**Carlyle/Eisenhower East Design Review Board (DRB)
Application**

PROJECT NAME: Blocks 4+5 Hoffman Town Center BLOCK: 4+5

Carlyle Design Review Board
Submission-July 18, 2019 Hearing
2410 & 2460 Mill Road
HTC Block 4 & 5
19-0007

RE: Hoffman Town Center, Blocks 4 & 5
DSUP #2019-0018
Comment Response Letter
Cooper Carry project# : 20160037

2 SOUTH ELEVATION
4-A4.01 SCALE: 1/16" = 1'-0"

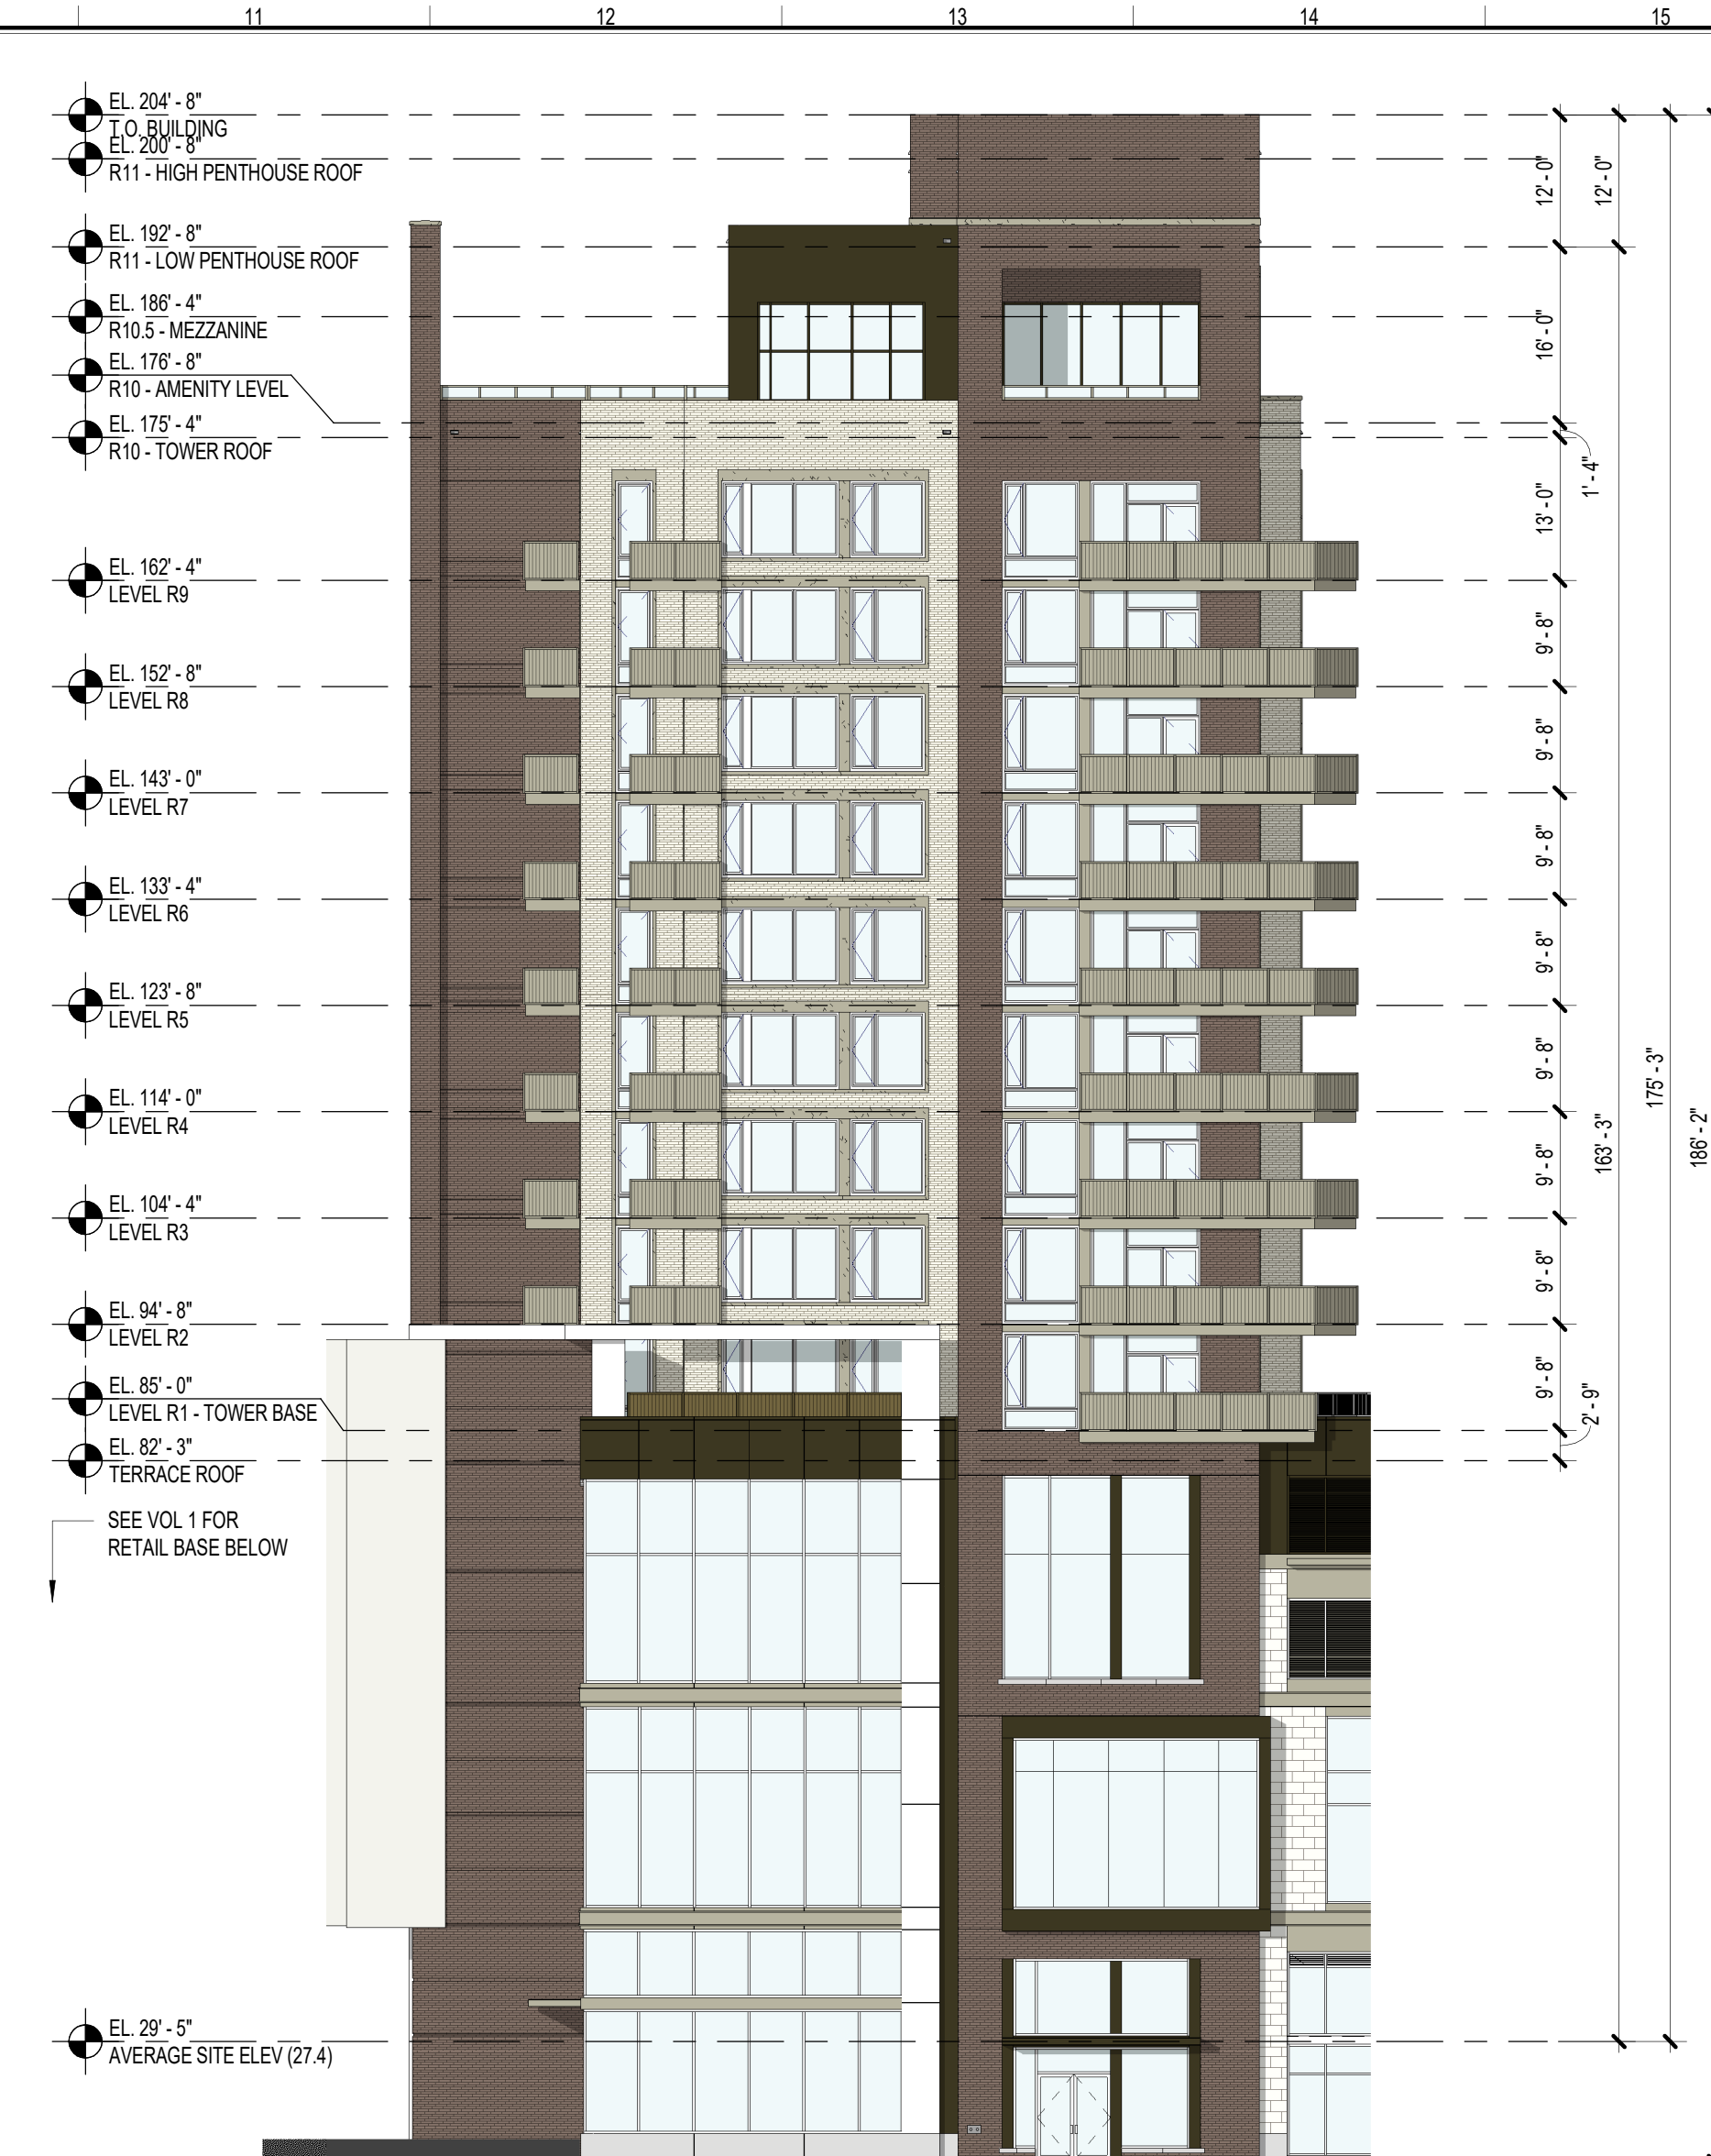
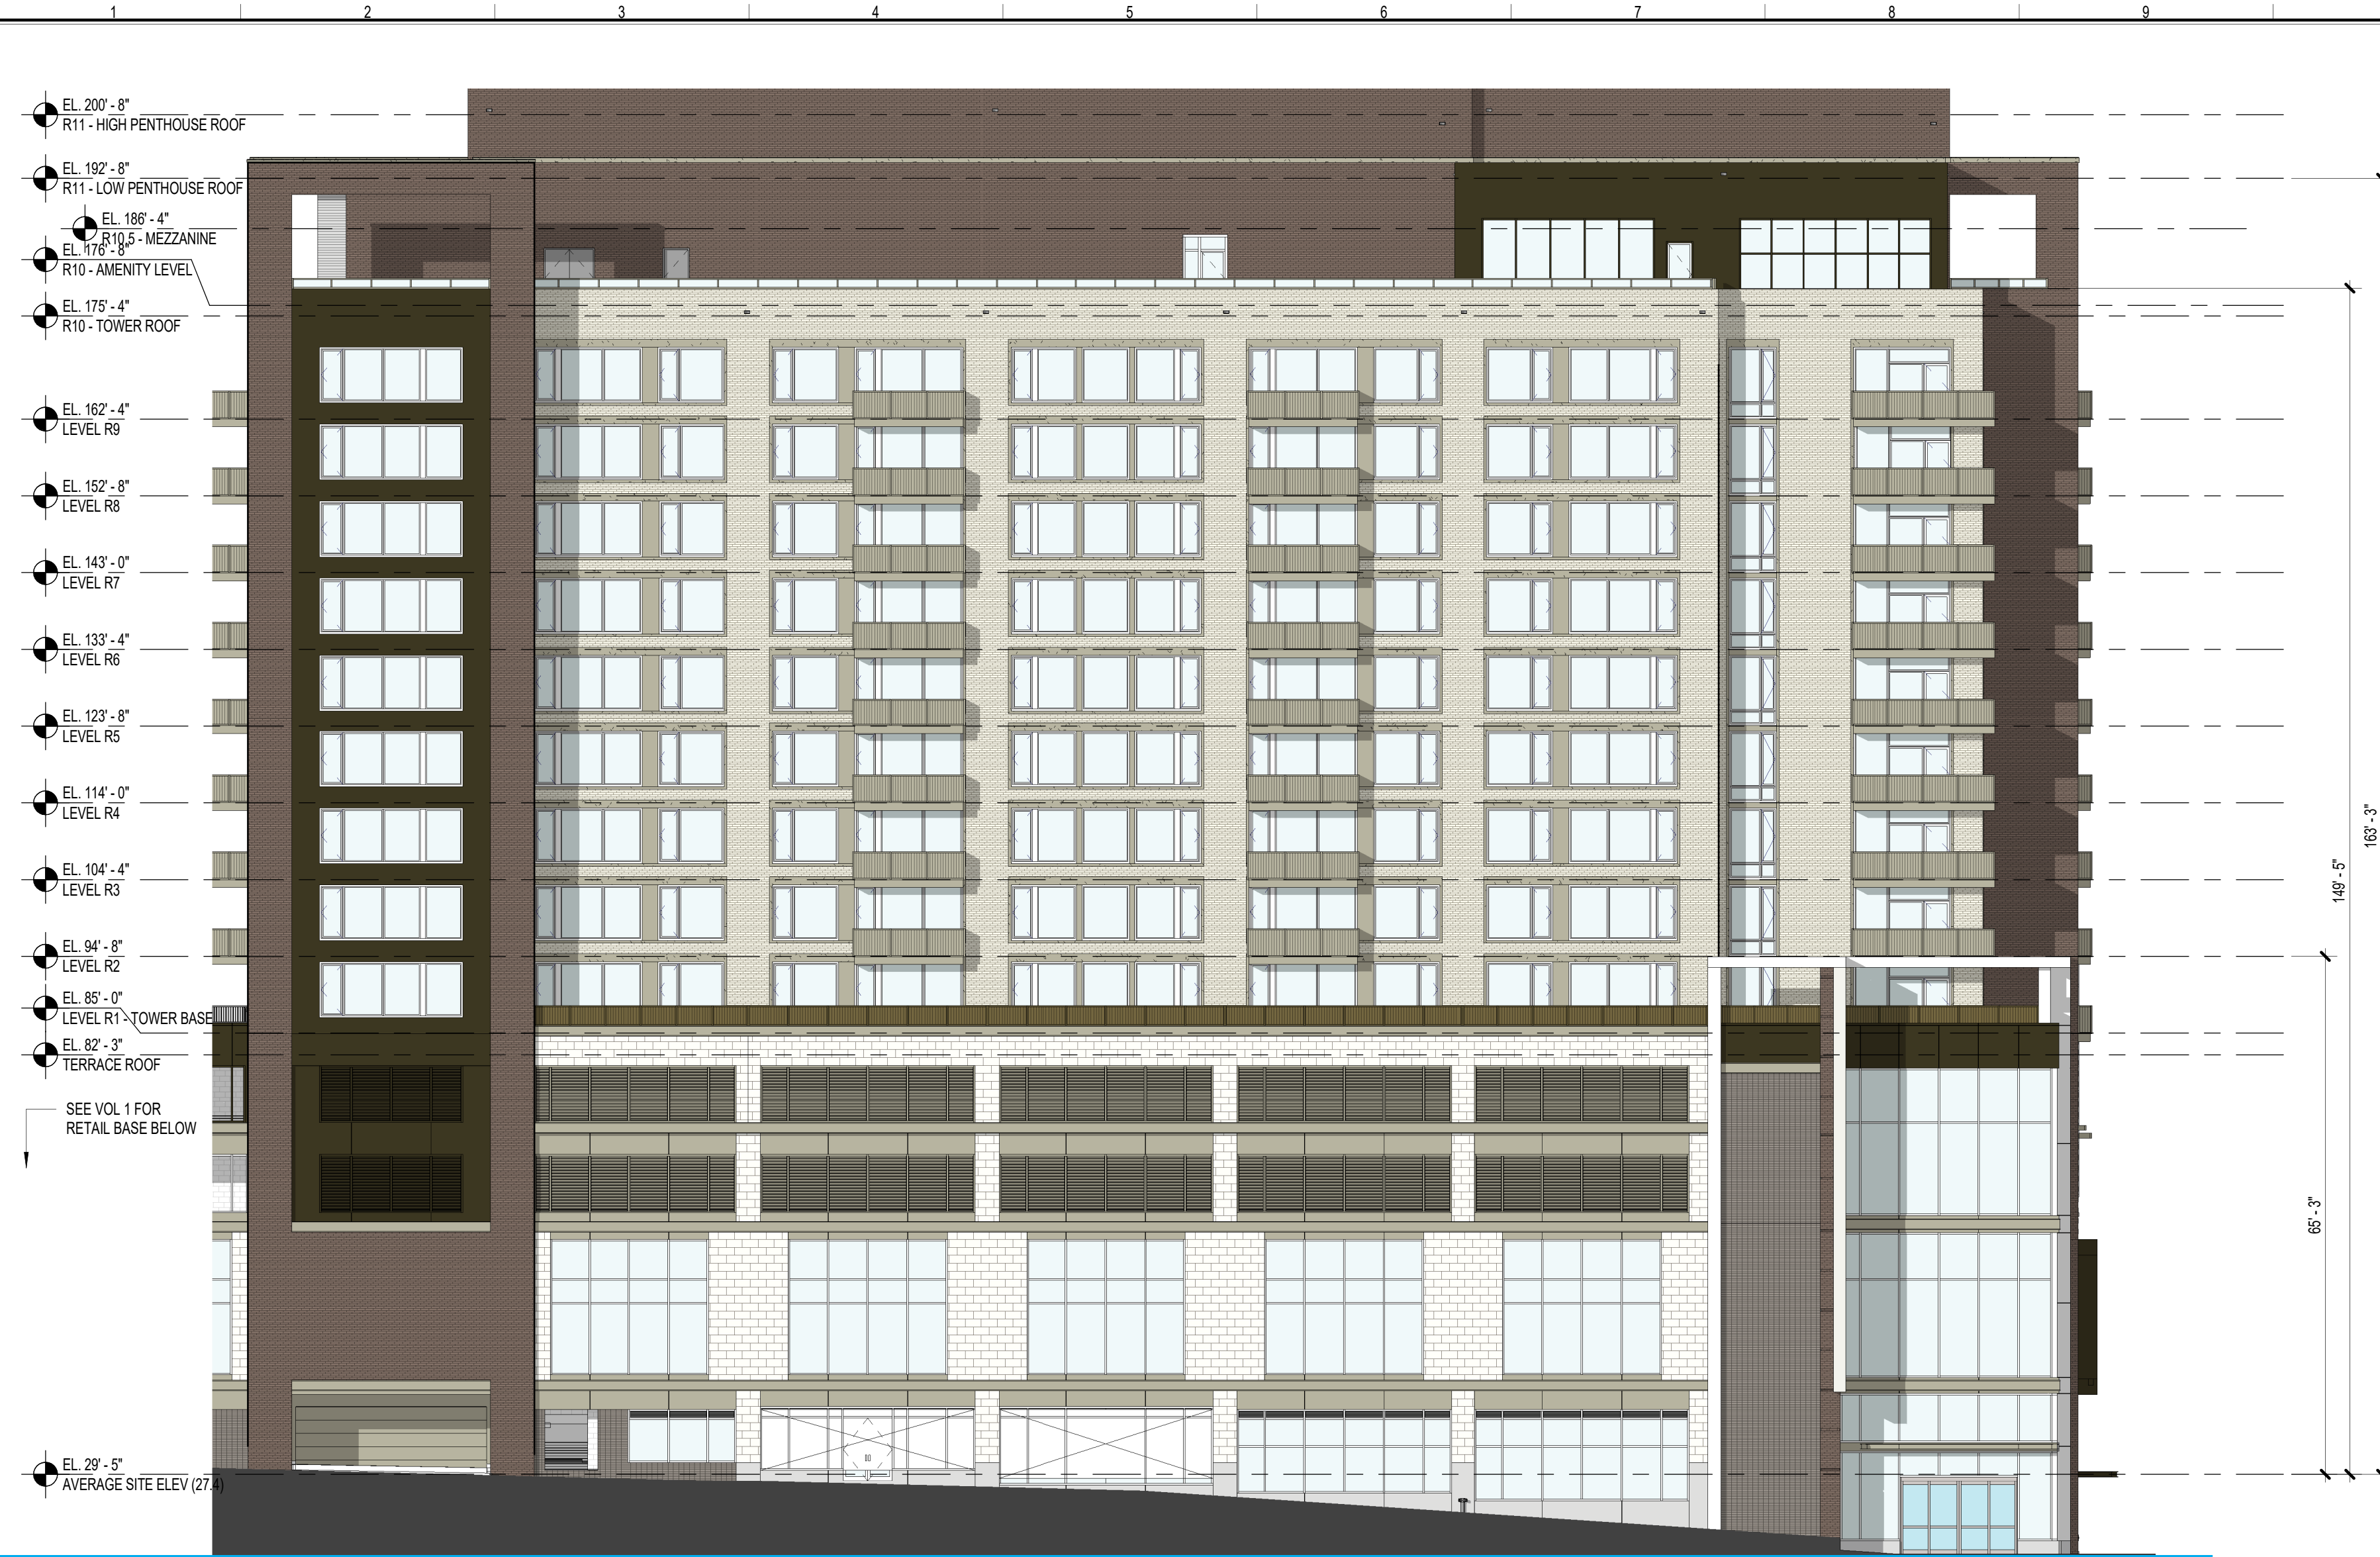
- e. The south end of the amenity level was a previously enclosed form and connected to the south-facing vertical accent as enclosed space. It is now a free-standing fin and appears much thinner than the corresponding one that faces west.

- f. The heavy return on the south face of the brown vertical accent negates the approved expression of the building element as a “thick wall” which projects well above and out from the primary building volume.

- d. Two entire vertical columns of south-facing windows have been deleted from the face of both the west brown vertical accent, and the south return face of the cream-colored central portion, creating two blank walls where there was corner glass.

- a. Major portion of the upper penthouse (approx.. 13' high x 153' long) previously aligned with the distinctive center features on both the west and east elevations and has been eliminated. Results in a longer, undifferentiated penthouse. (west elevation)

Response: The south end of the amenity level has been revised to be an open volume. It has been given the language of the “basket handle” to match that of the west and northeast elements.

Response: The south face of this accent has been modified with the footprint change in the DSUP amendment. It now recesses into the volume accentuating the 2'-8" “thick wall” as it carries down to grade. To articulate what otherwise would be a blank wall on this elevation, further texture has been added to this wall by adding reveals which align to the datum of window sills and headers.

Response: The vertical column of windows in the cream-colored brick has been restored. The column of windows in the brown vertical accent has not been returned due to conflicts with the interior unit layout. However, as to not have a blank wall on this elevation, further articulation has been added to this wall by adding reveals which align to the datum of window sills and headers.

Response: The upper penthouse has been elevated to be more consistent with the original architecture. It now stands 10'-0" high x 187'-0" long.
